## COMMUNITY DESIGN REVIEW BOARD STAFF REPORT

**AGENDA ITEM:** Design Review Resolution, Century Ponds Proposed Development, 601 Century Avenue South

**Public Works Plan Review**

**PLAN SET:** Plans dated 7-22-2025

**CENTURY PONDS**  
 MAPLEWOOD, MN  
**PRELIMINARY PLAT**  
 GRADING PLAN - VIEW A

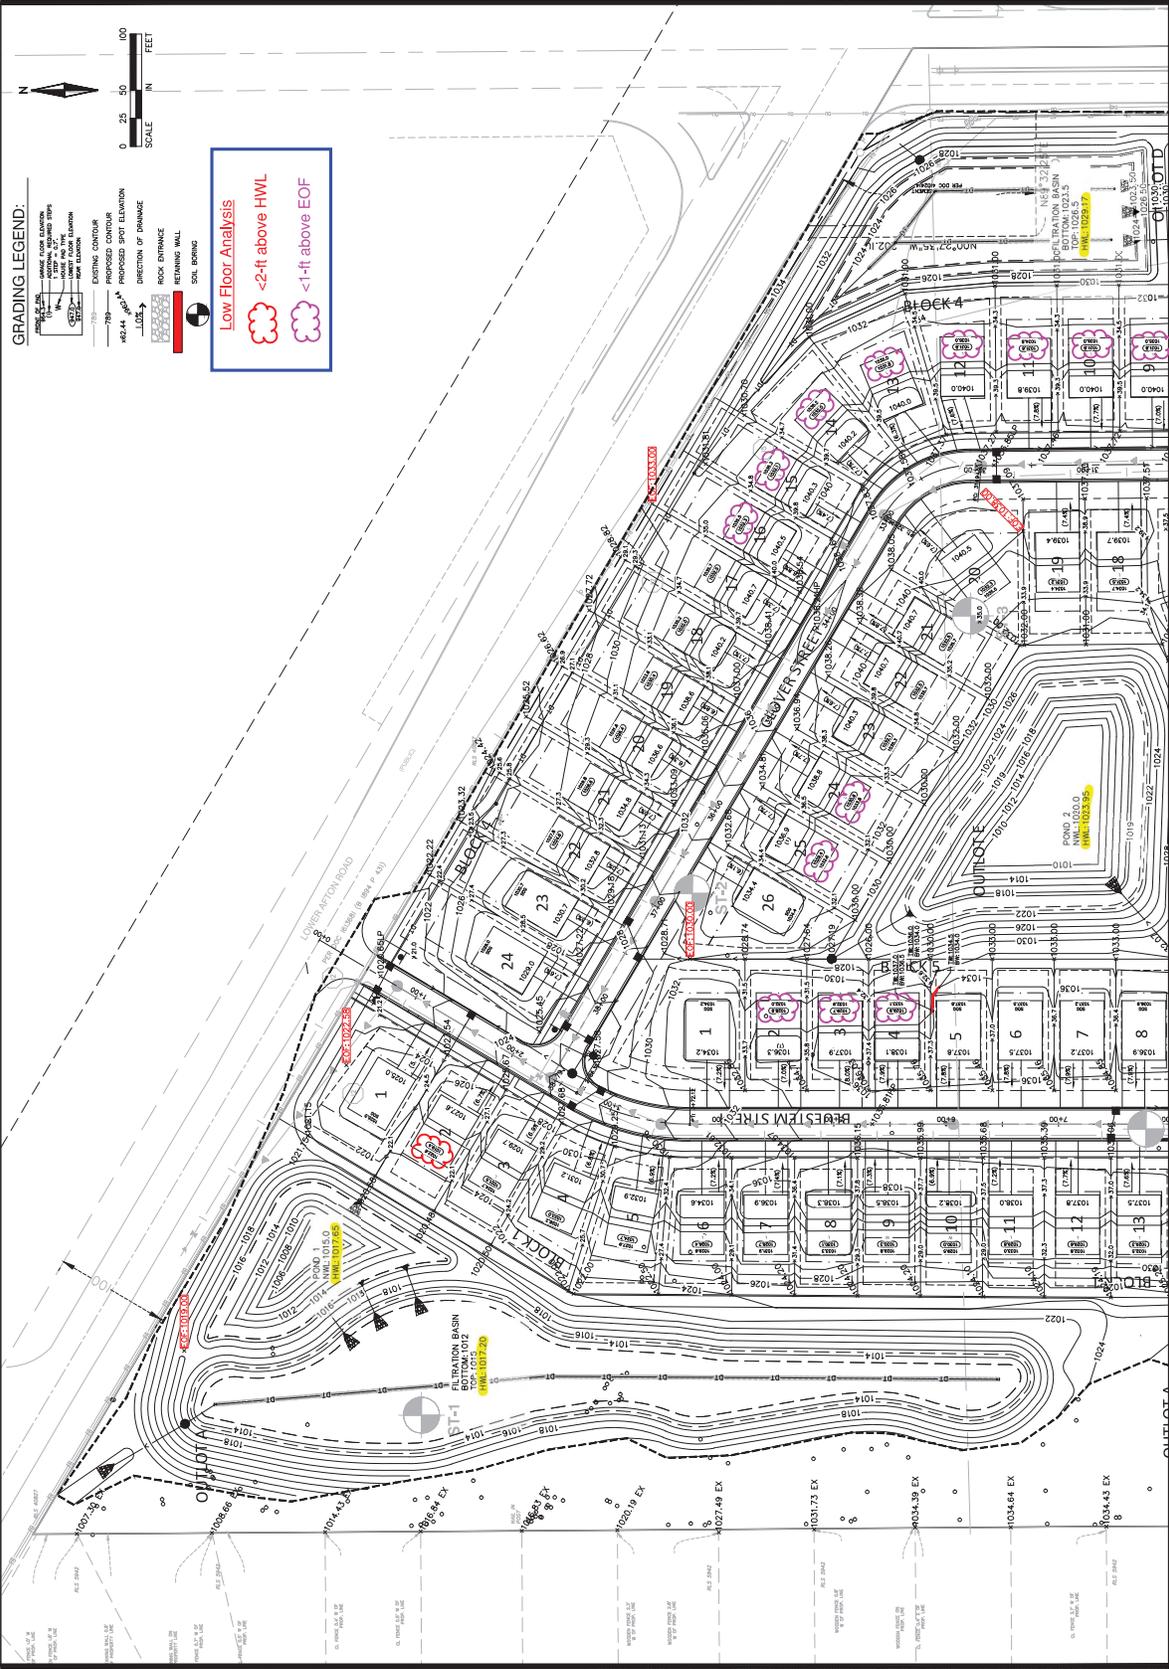
- 15) The notes to contractor on sheet 23 reference the RAHR Preserve. Please adjust to the current project. In this same note, there is reference to the mass grading contractor turning over NPDES responsibilities to the Developer and City. Please revise this note to eliminate the City from the parties responsible.
- 16) A double row of silt fencing or other perimeter control measures are required between all site grading and wetlands.
- 17) A rock construction entrance is required where Indigo Avenue intersects with Century Avenue. Please display this on sheet 25.
- 18) Existing contours shall be shown outside of the development grading limits so that it can be seen how the site ties into adjacent areas.
